DESIGN REVIEW PERMIT ANALYSIS

As noted above in the Coastal Development Permit (CDP) analysis, the proposed project consists of construction and operation of a 16,157-square-foot, one-story, retail store with a 55-space parking lot and associated improvements, landscaping, and infrastructure. The proposed visual conditions are shown in the visual analysis prepared for the Environmental Impact Report. The project is subject to Design Review per Section 17.71.050 of the CLUDC and must conform with the Citywide Design Guidelines.

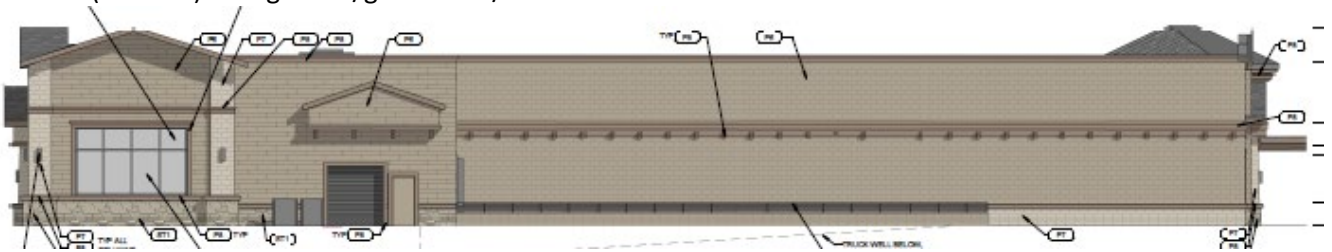
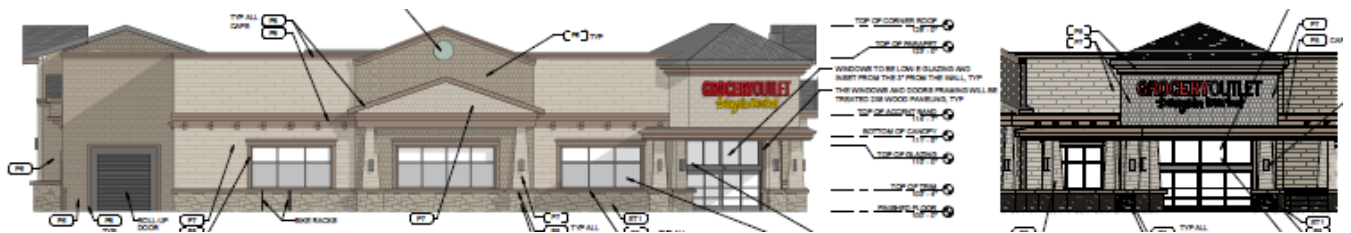
However, this standard design does not comply with the Citywide Design Guidelines. Therefore the applicant was asked to develop a design that complies with the Citywide Design Guidelines. The submitted design is illustrated in the photos on the following page and in Attachment 3: Grocery Outlet Floor Plan Elevations.

1. The roof Parapet does not “include detailing typical of Fort Bragg’s character and design.” The proposed project does not use much architectural detailing on the parapet. The Planning Commission can recommend Special Condition 22.

- Windows are incorporated at the storefront location and includes use of clear glass (at least 80% light transmission). However as proposed these windows would be painted with murals which would reduce light transmission significantly. Special condition 23, above, will address this issue.
- The size and location of doors and windows relate to the scale and proportions of the overall structure.

- The front façade includes the following materials for the exterior elevation from the Encouraged List: Hardi Board Composite, Wood Paneling, Hardi Board Composite Half, Round "Fish Scale" Paneling, Wood Roof Shingles.
- It also includes the following materials from the Acceptable List: Cultured Stone with an authentic appearance, and Country Ledgestone.
- However, the project includes Smooth Face CMU, which is considered a “discouraged” building material. The CMU is proposed for portions of the building fronting Franklin Street and South Street and the west face of the building which fronts the property line with the gas station.

Special Condition 22: The applicant shall submit a revised design that includes additional detailing in the parapets for consideration and approval by the Community Development Director.
